# PLATTE SELF STORAGE

## GRADING AND EROSION CONTROL PLAN

### OVERVIEW SHEET

AUGUST 2024

**ACCESS ROAD - PLAN & PROFILE**  
HORZ SCALE: 1"=40' - VERT SCALE: 1"=4'

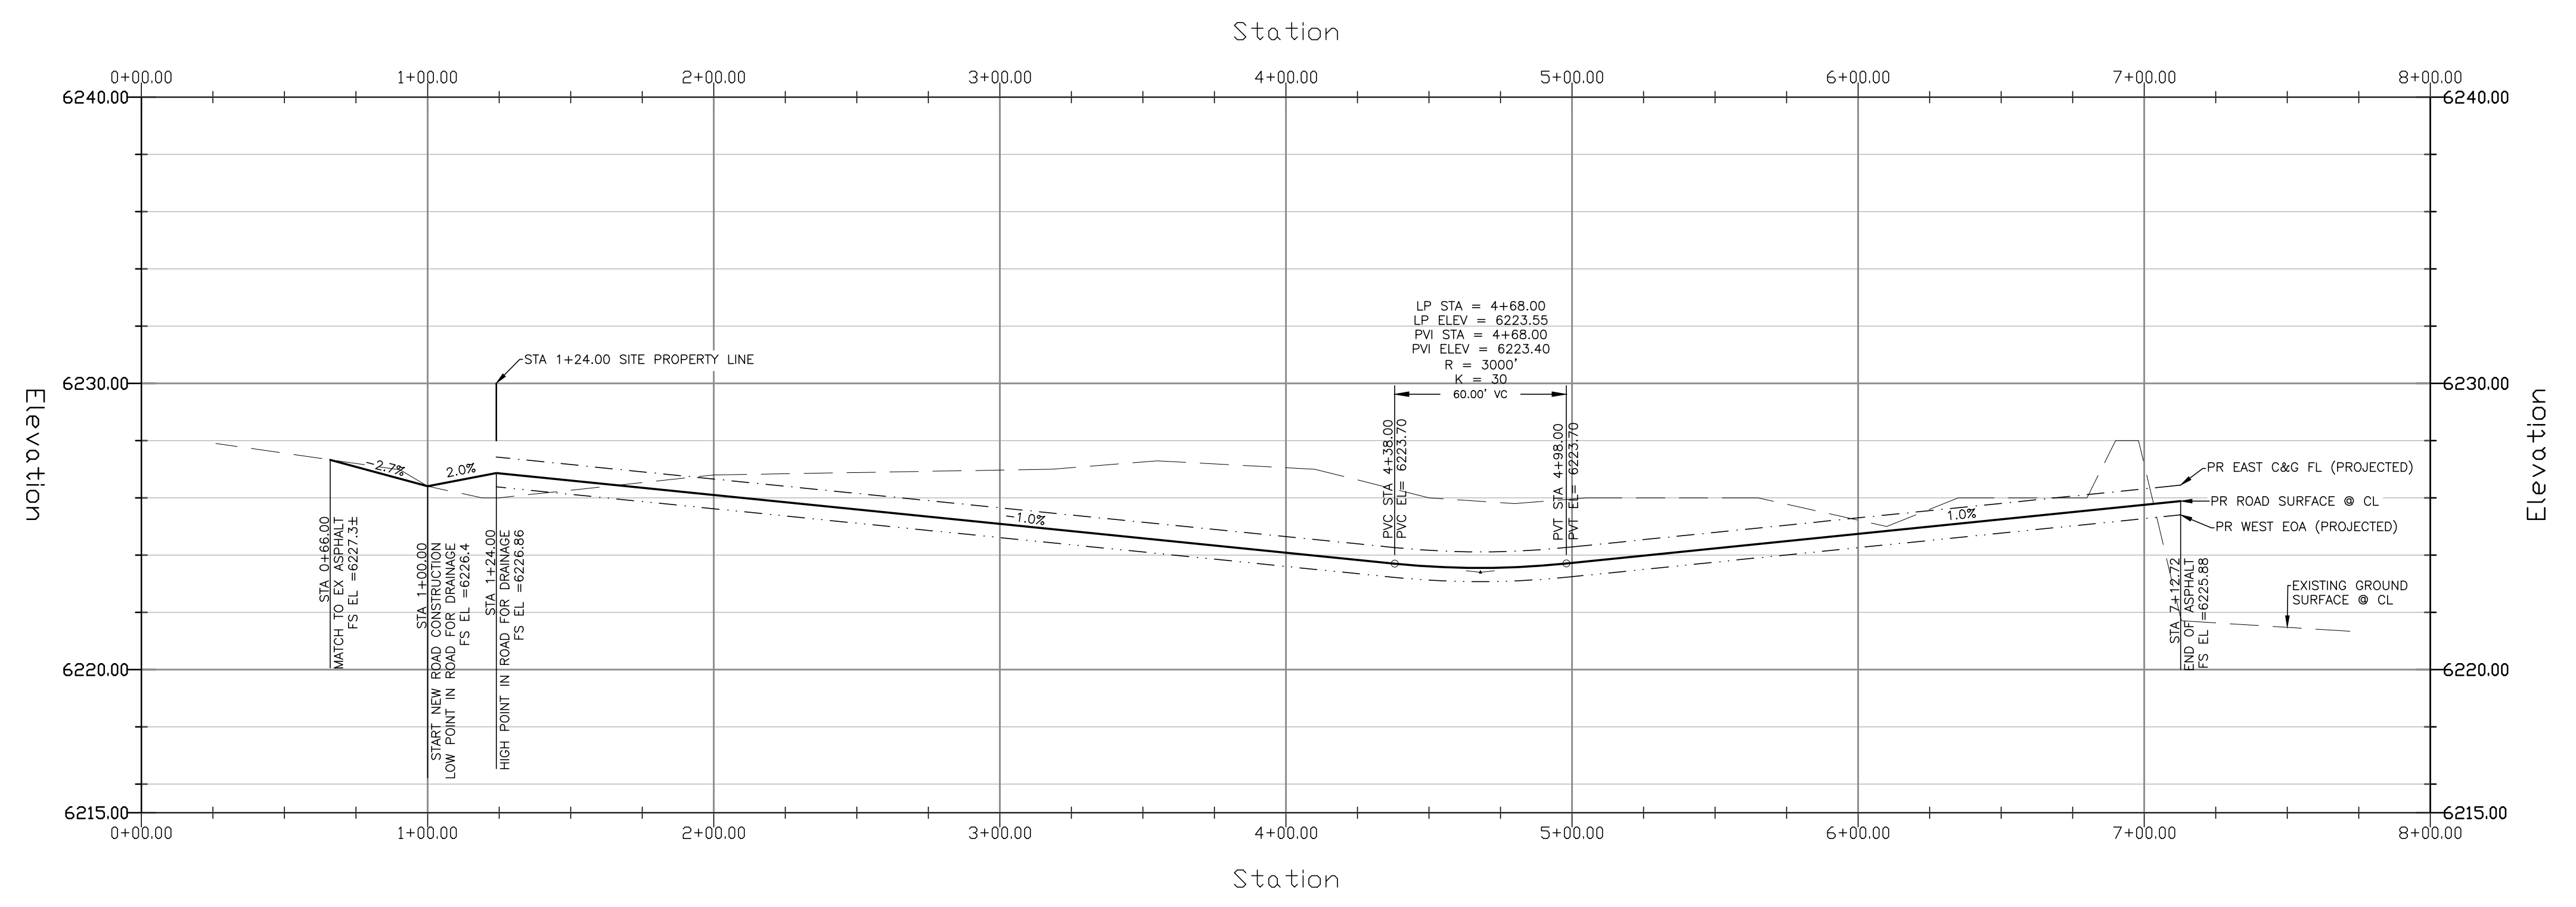
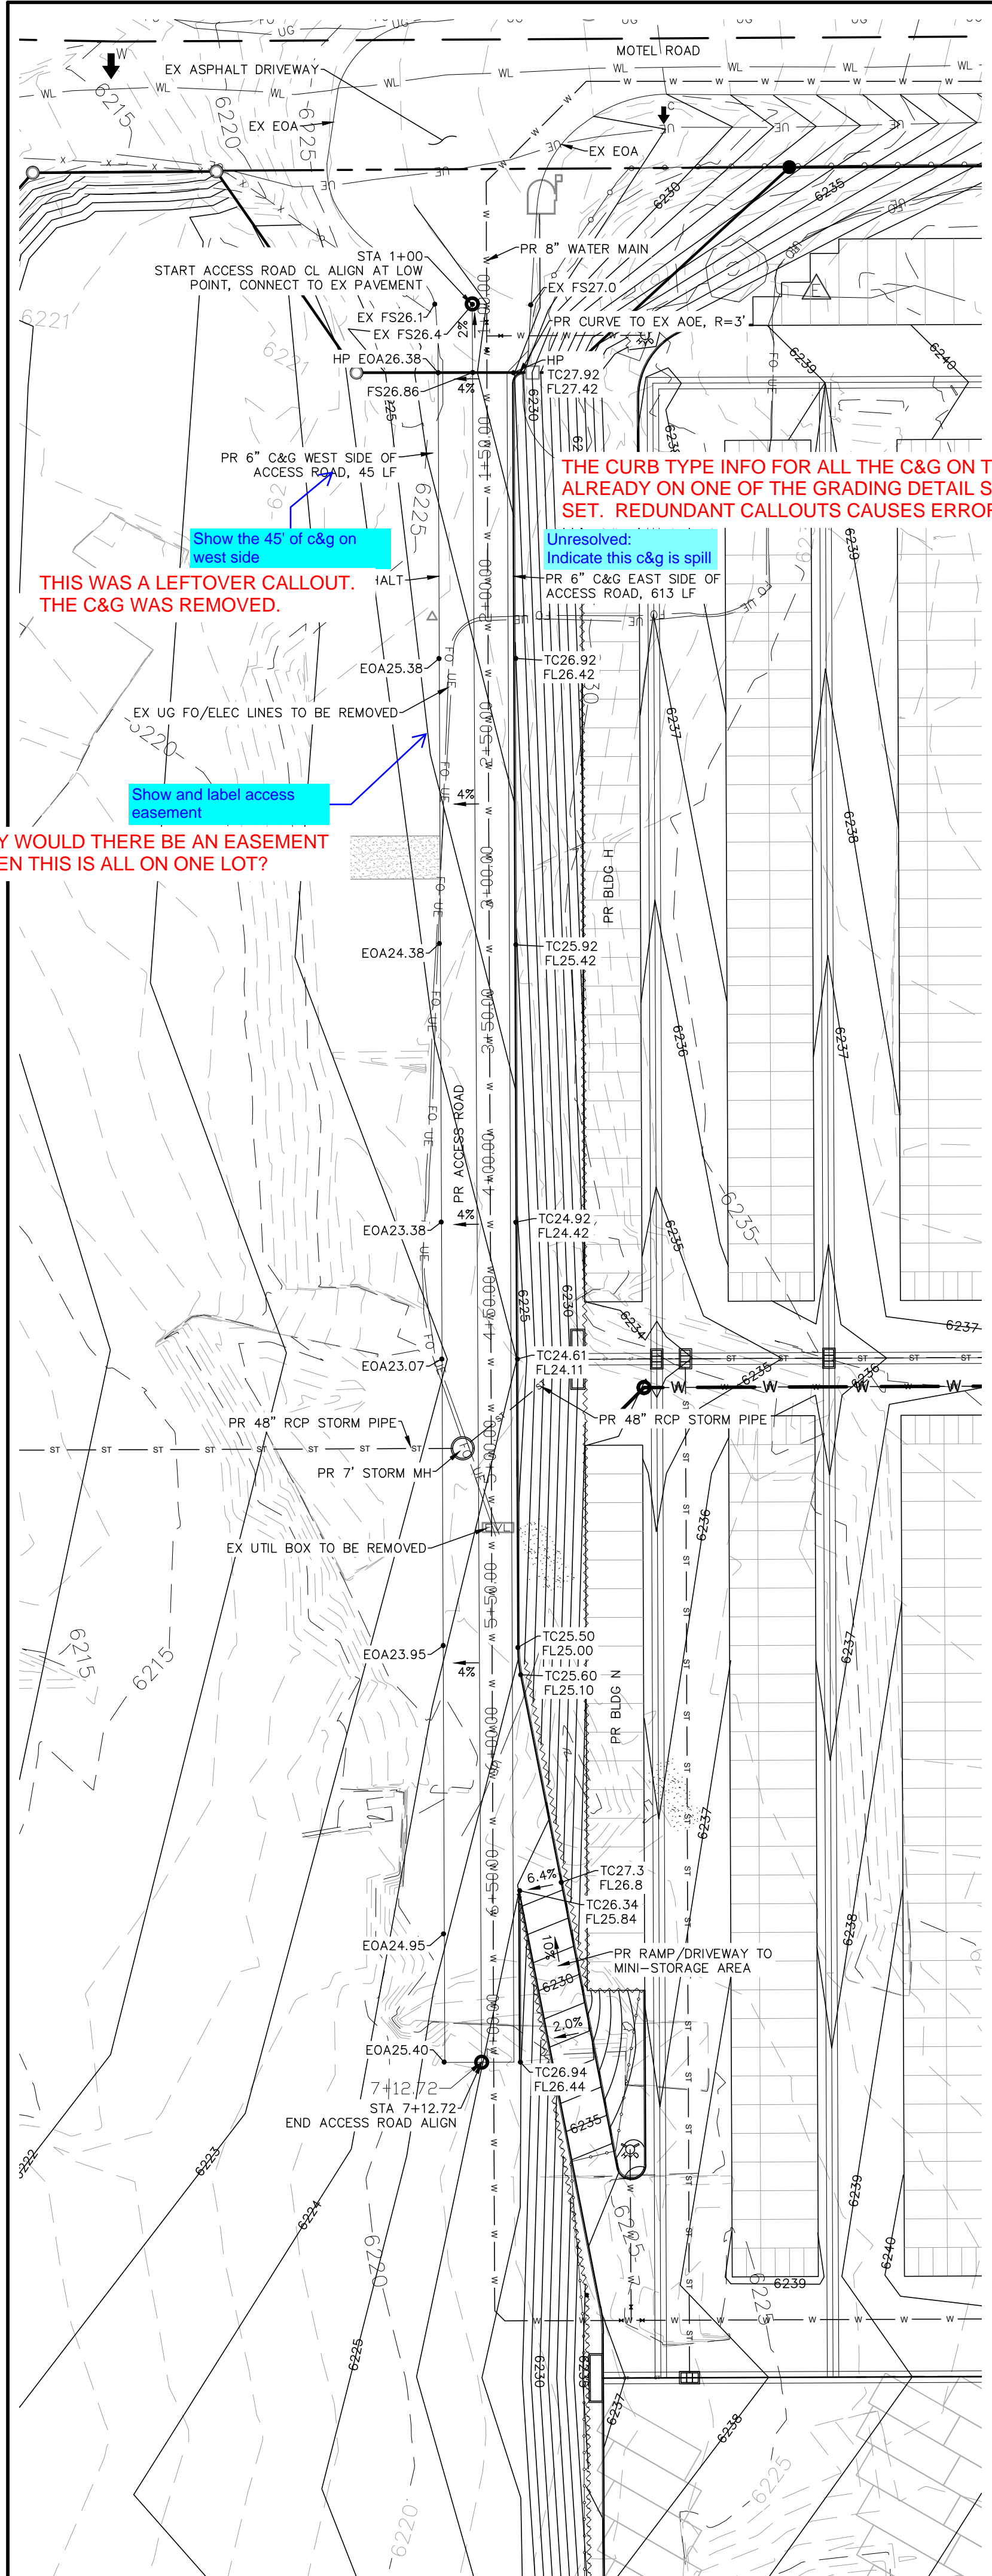
Show and label access easement

WHY WOULD THERE BE AN EASEMENT WHEN THIS IS ALL ON ONE LOT?
